United States Environmental Protection Agency
Region I - New England
5 Post Office Square, Suite 100
Boston, Massachusetts 02109-3912

Re: Request for Information ("RFI"), Docket No. CWA-308-R01-FY17-24 for METRO Building located at 21 Metro Way, Barre, Vermont

Attachment A

**EPA Inspection
11/14/16**

METRO Building
21 Metro Way
Barre, VT 05641
EPA Inspection 11/14/16

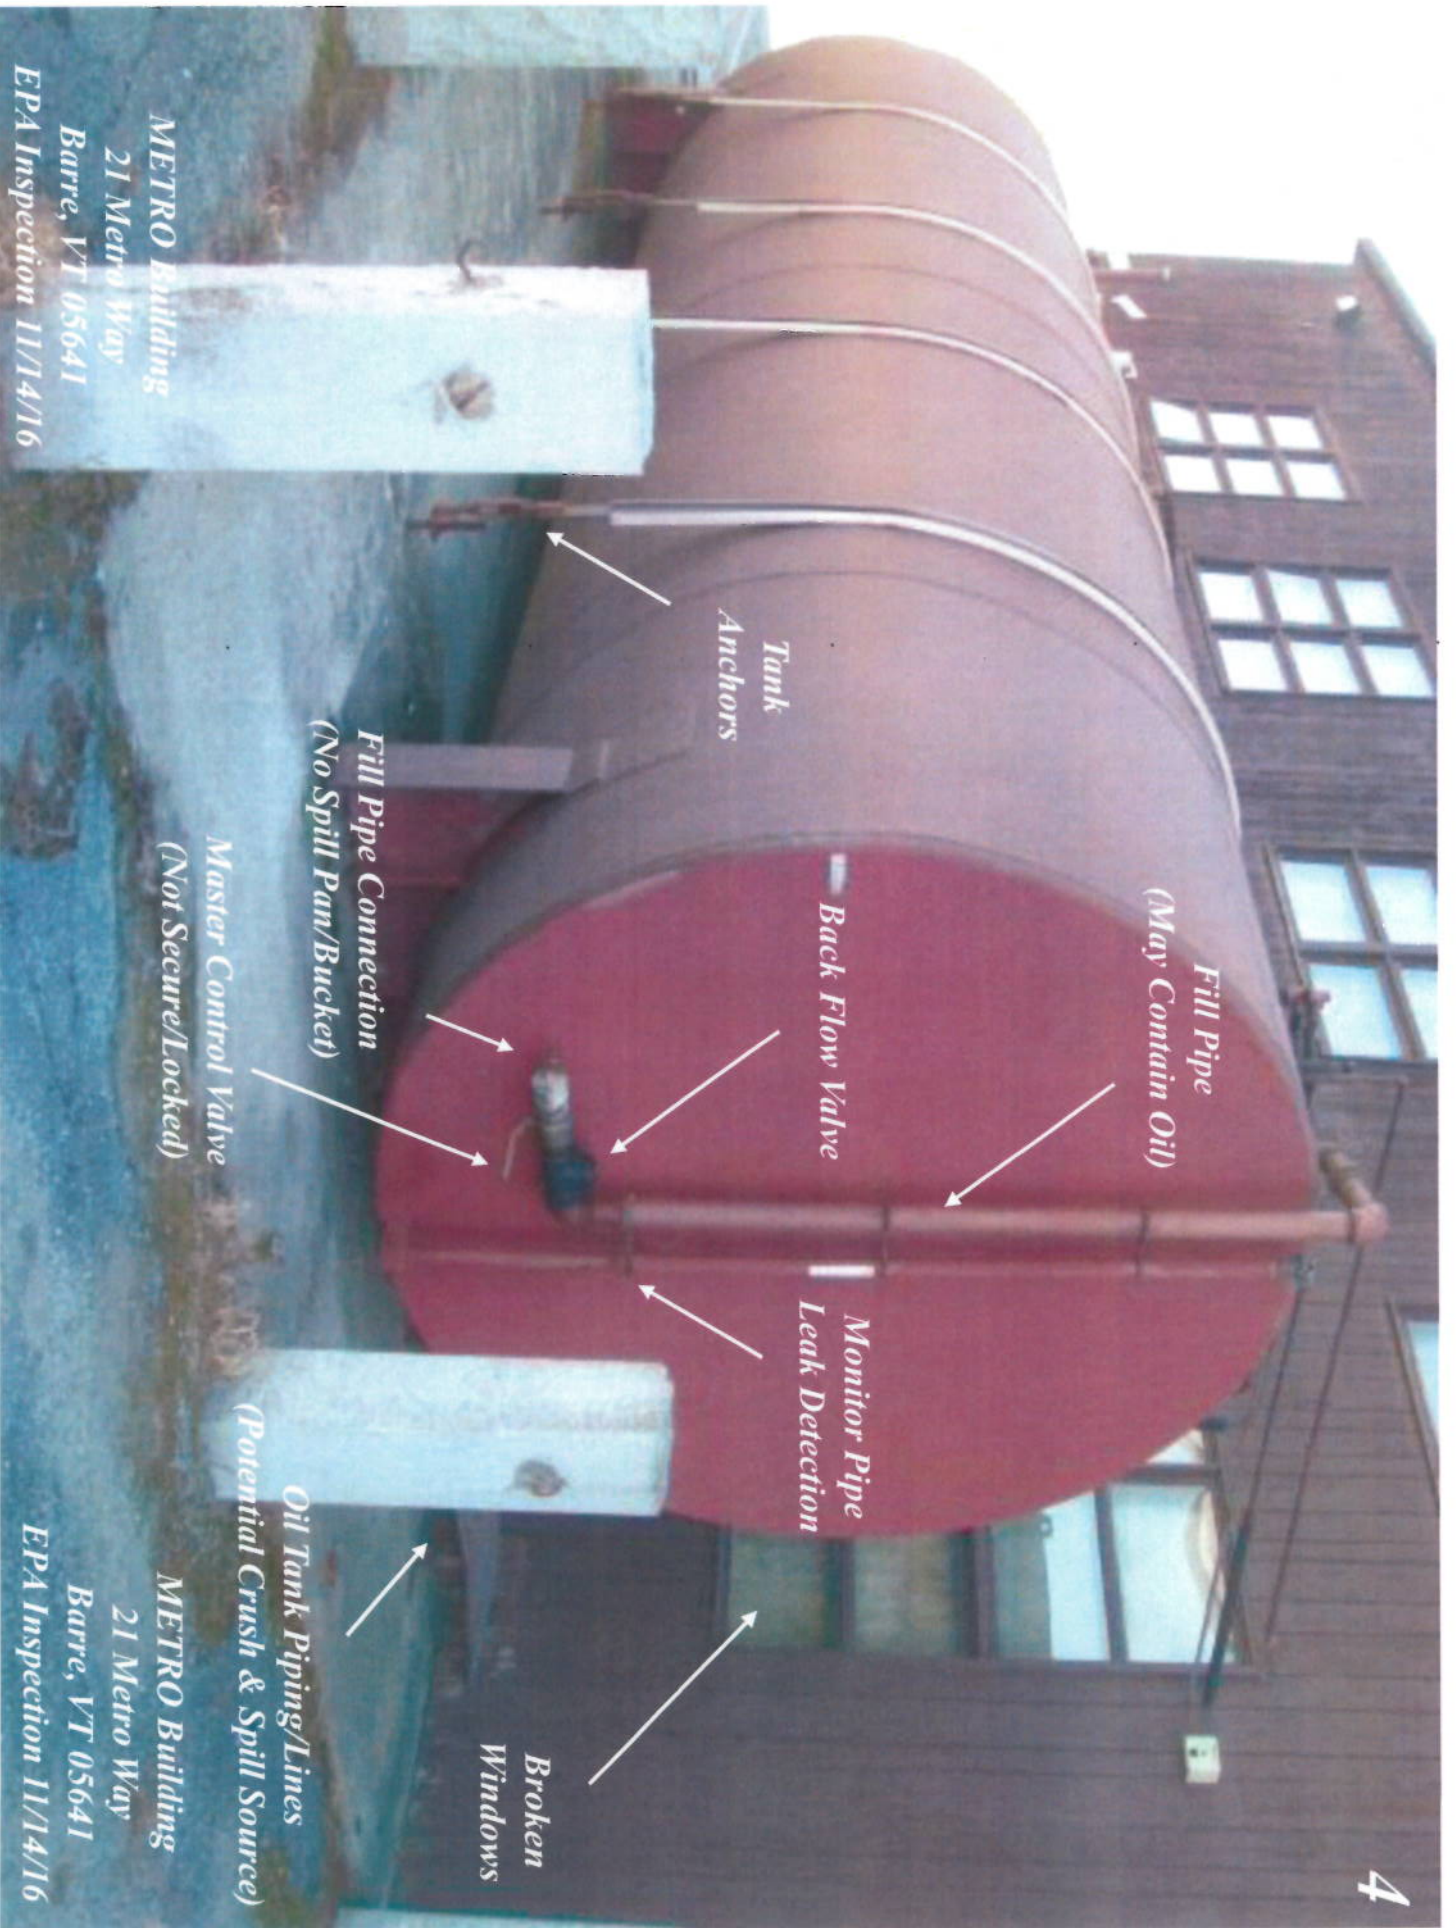
Vent
(No Overfill Prevention)
(Audible Air Vent?)

Double Wall
20,000 Gallon
No. 2 Oil Tank
(Volume & Contents Not Labeled)

Fill Pipe
(May Contain Oil)

Fill Pipe Connection
(No Spill Pan/Bucket)

Master Control Valve
(Not Secure/Locked)

Oil Tank Piping/Lines
(Potential Crush & Spill Source)

Broken
Windows
